Addendum No. 1
Page 1 of 2

TO: Prospective Bidders
SUBJECT: Addendum No. 1
PROJECT NAME: Romeoville B Entrance Canopy
JJC PROJECT NO.: B20016

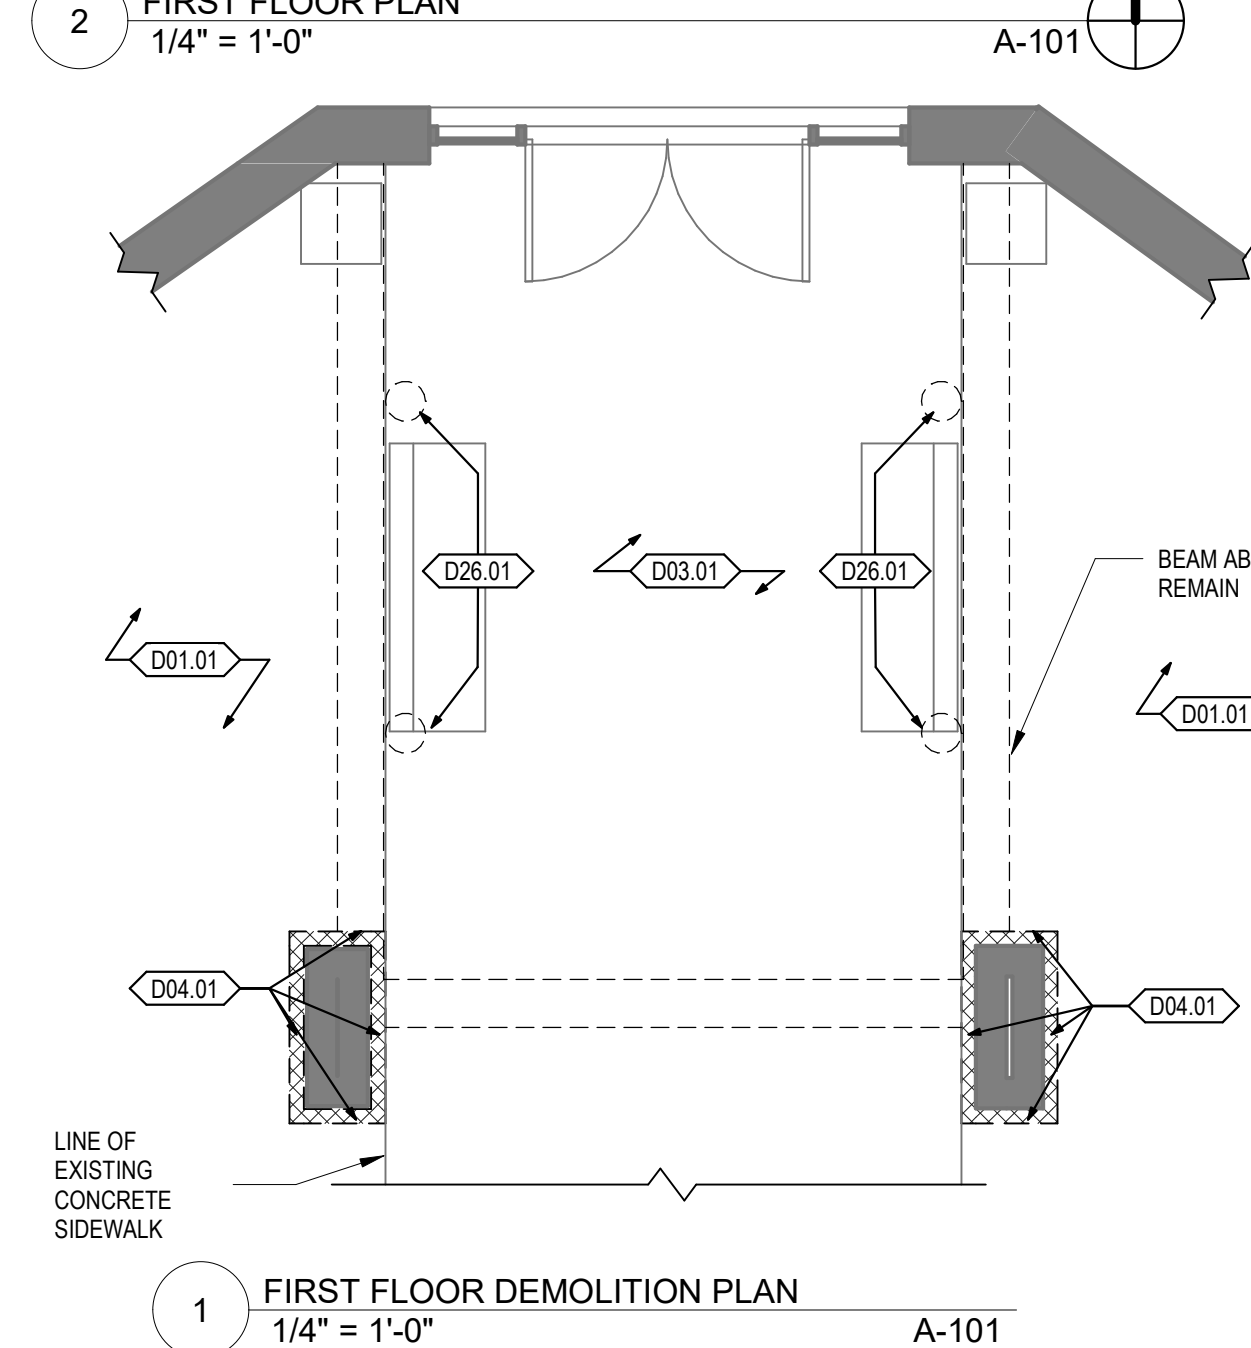
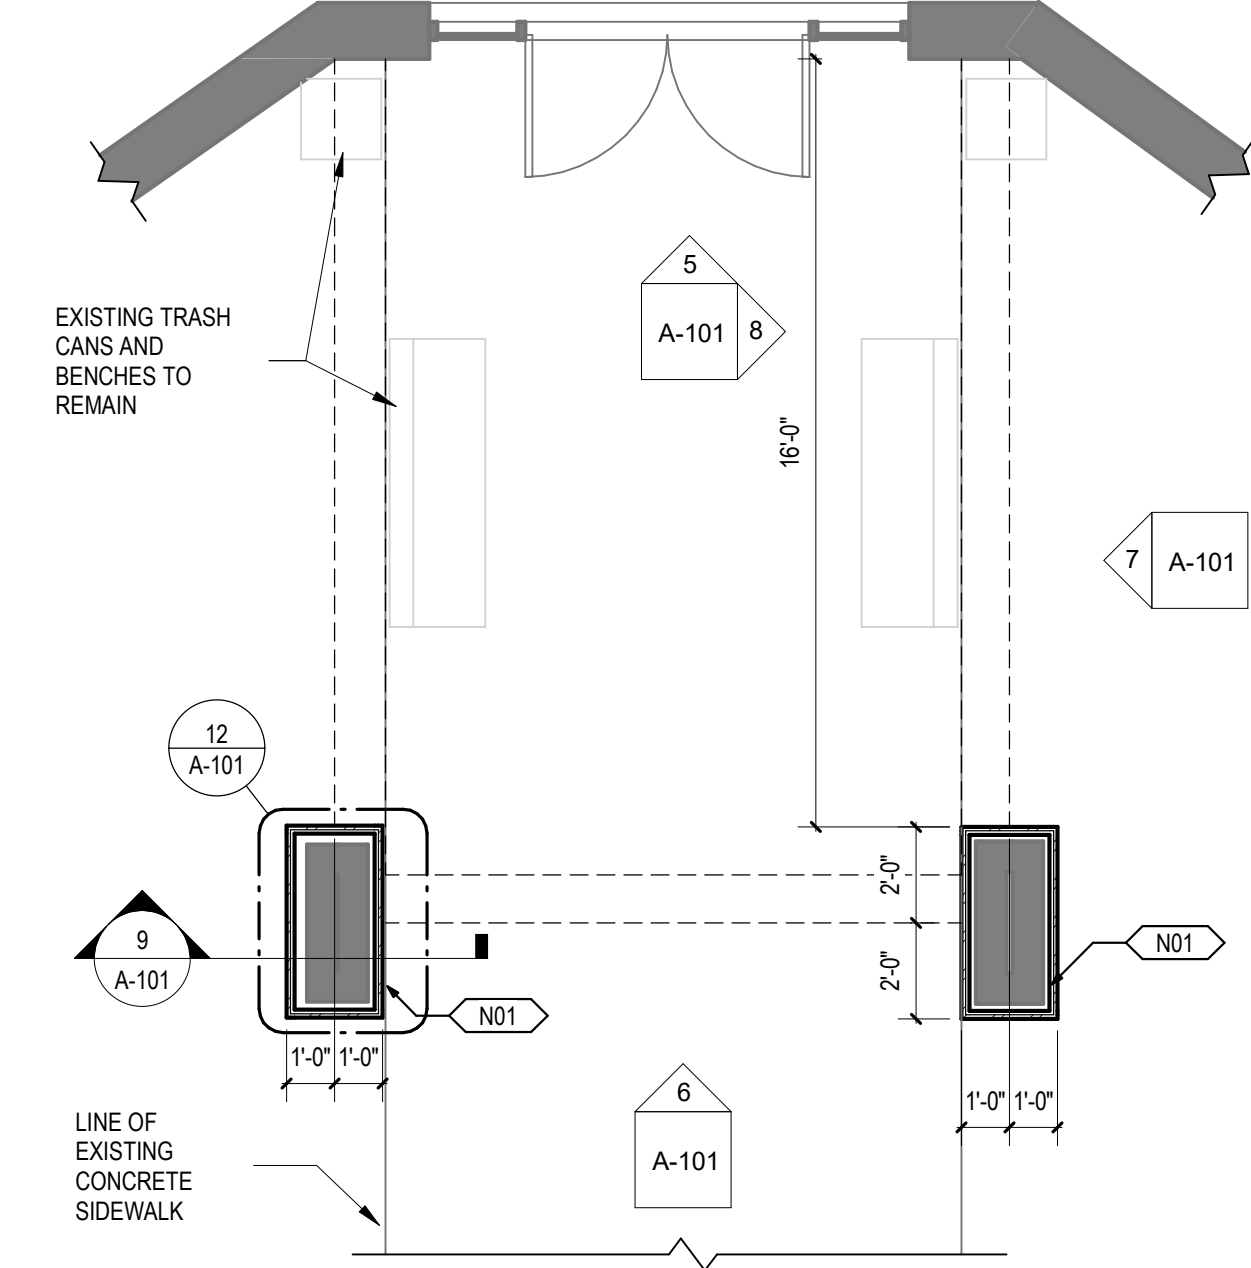
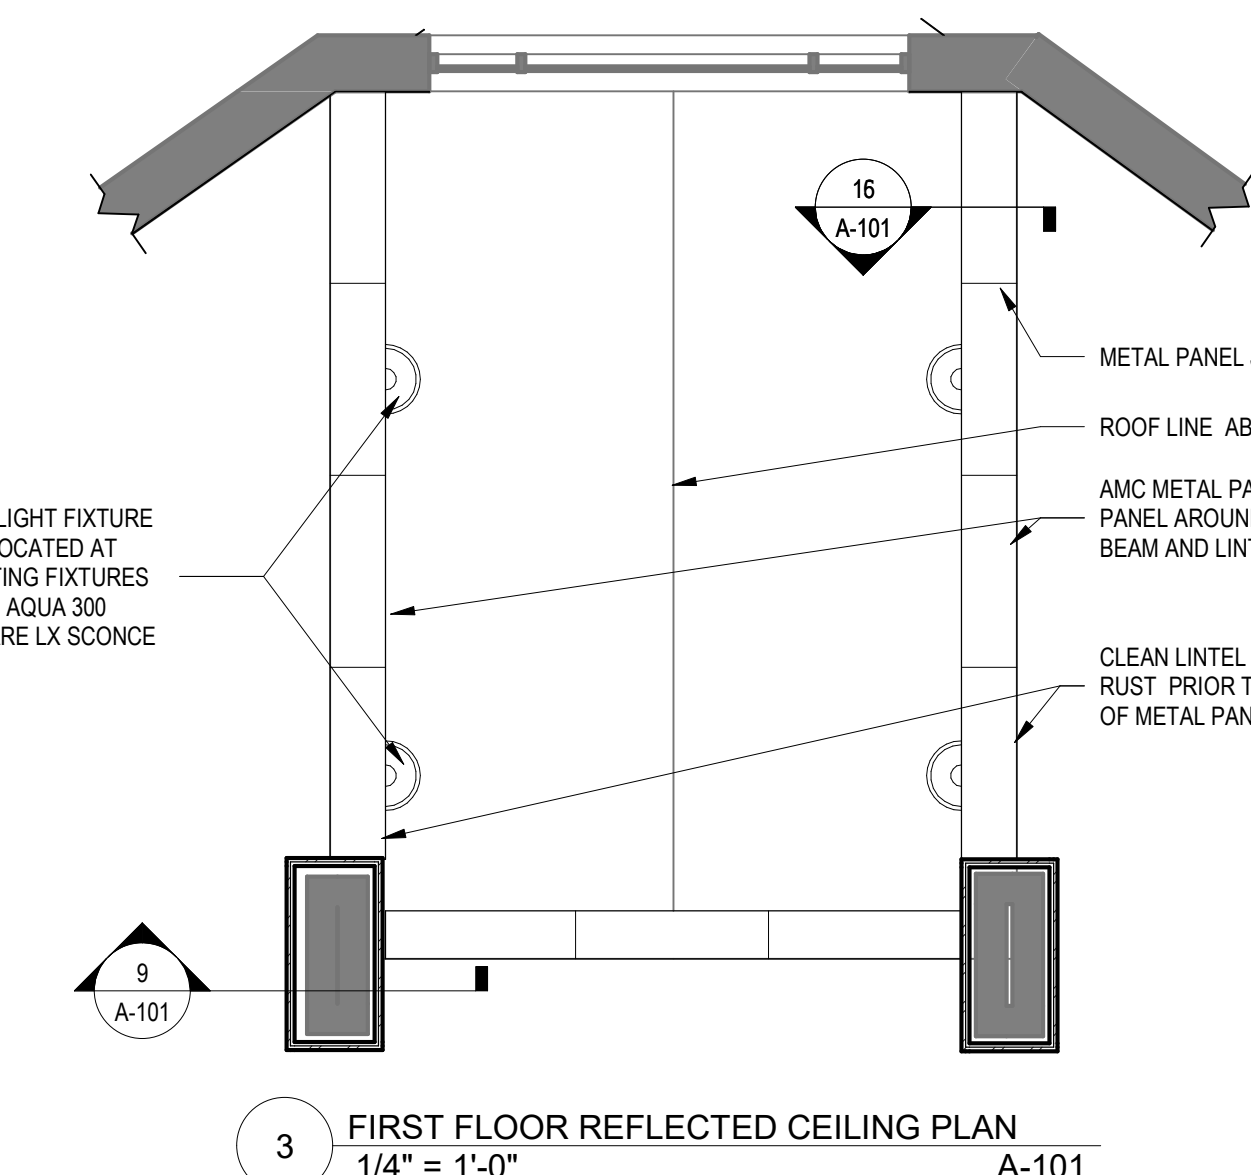
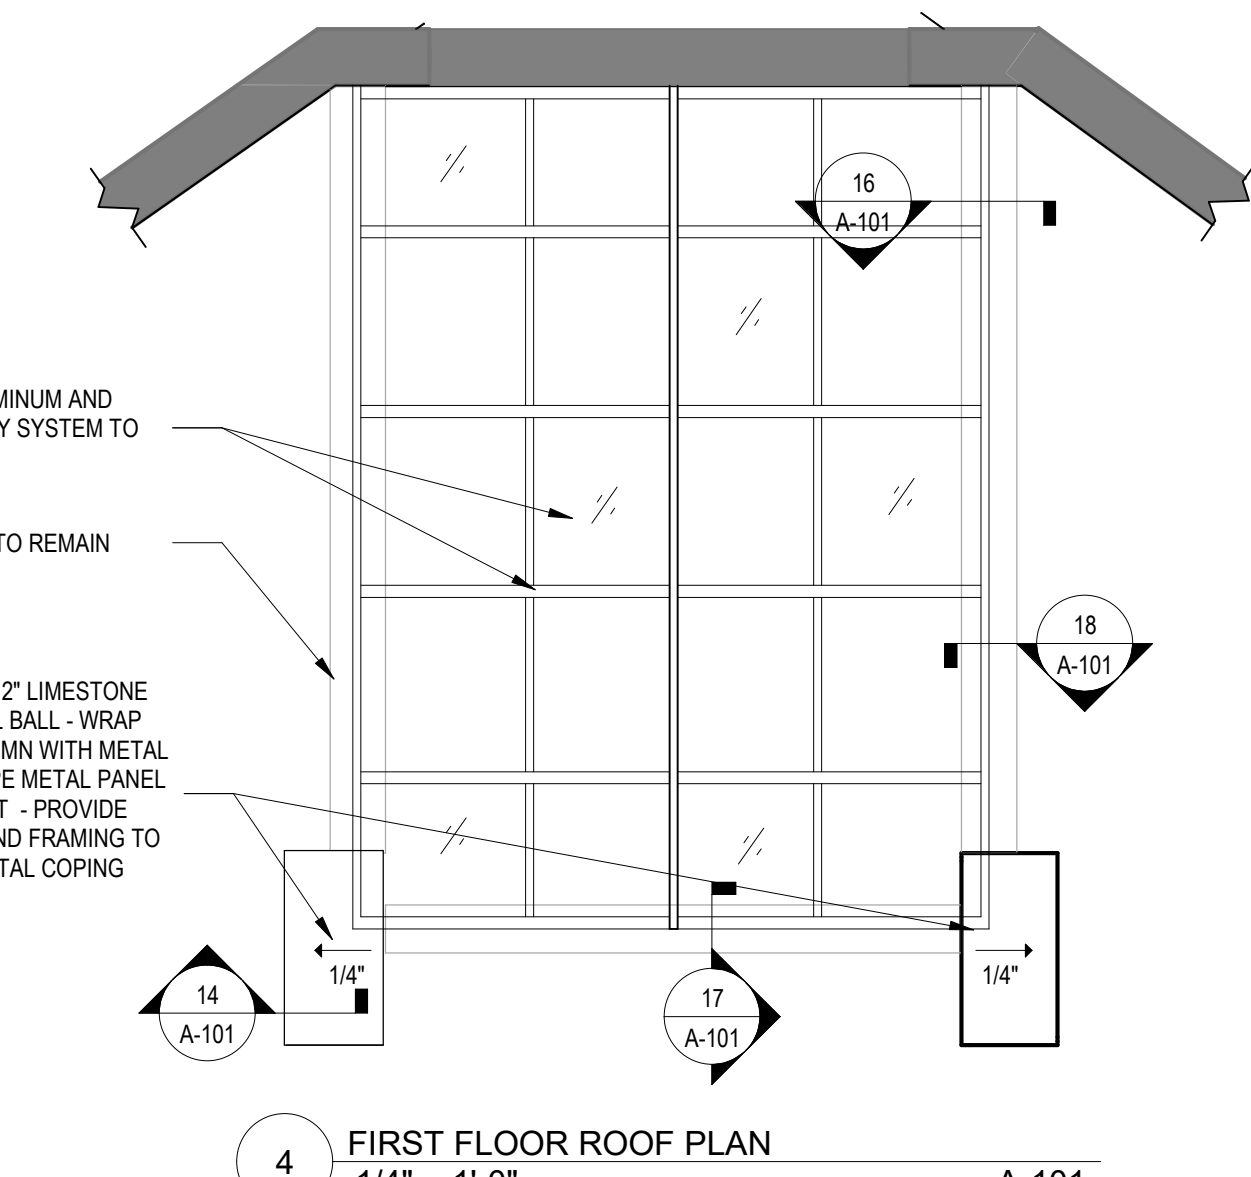
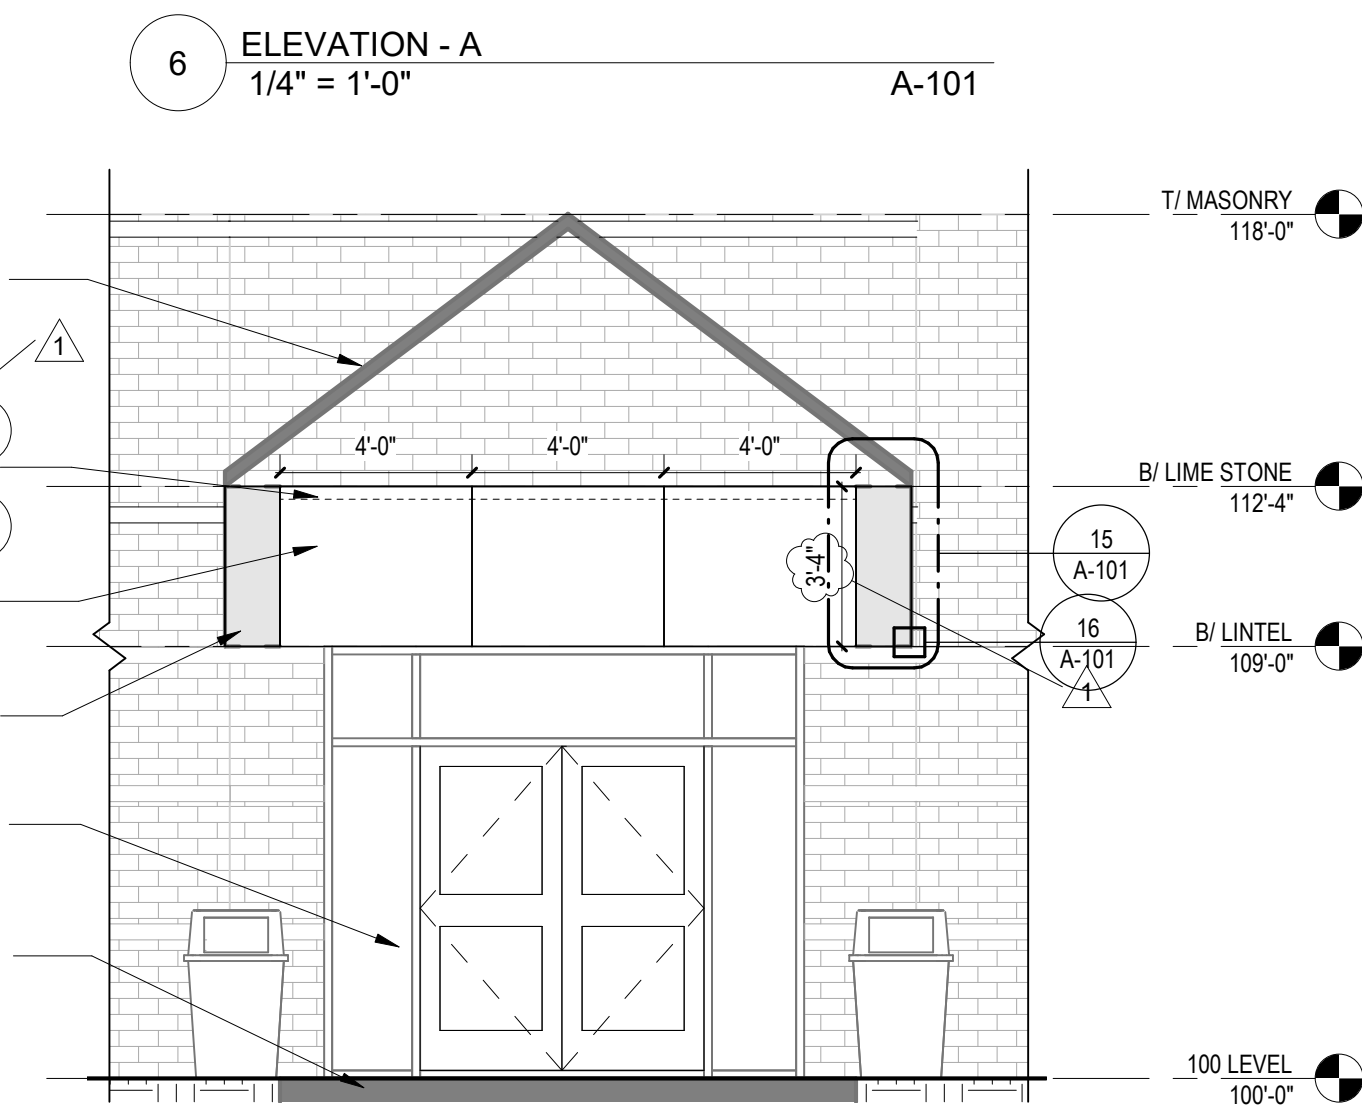
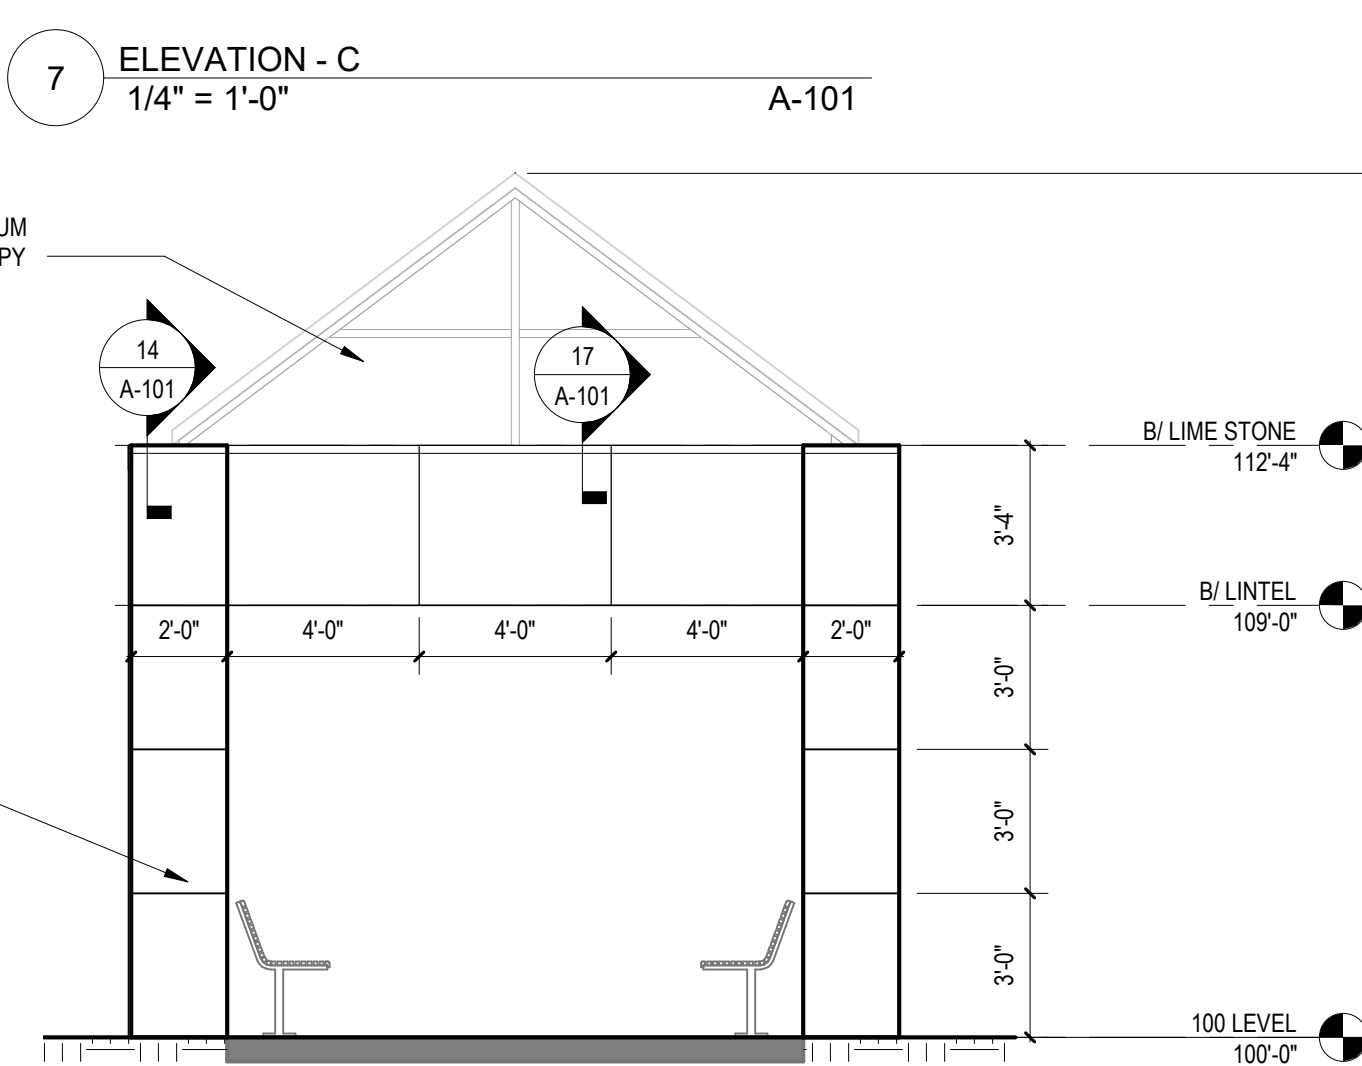
1. INCREASE HEIGHT OF AMC PANEL ABOVE STOREFRONT ENTRANCE:
 - a. REVISE HEIGHT OF AMC PANEL TO 3'-4".
 2. Details 10/A-101 & 11/A-101 & 14/A-101 & 17/A-101 & 18A-101, titled correspondingly, DETAIL - METAL PANEL CONNECTION & DETAIL - METAL PANEL CONNECTION AT BASE & DETAIL - AT TOP OF COLUMN & DETAIL - FLASHING AT TOP OF CANOPY & DETAIL - FLASHING AT TOP OF CANOPY

- a. At LOCATION OF WEATHER BARRIER:
 - i. ADD $\frac{3}{4}$ " PLYWOOD AND WOOD BLOCKING AS INDICATED ON DRAWINGS
 - ii. REVISE DIMENSIONAL WOOD BLOCKING.

- iii. RELOCATED WEATHER BARRIER OVER PLYWOOD
 3. Drawing 16/A-101, titled, DETAIL - METAL PANELS AT BEAMS.
 - a. AT BOTTOM OF BEAMS - REVISED WEEPING SOLUTION:
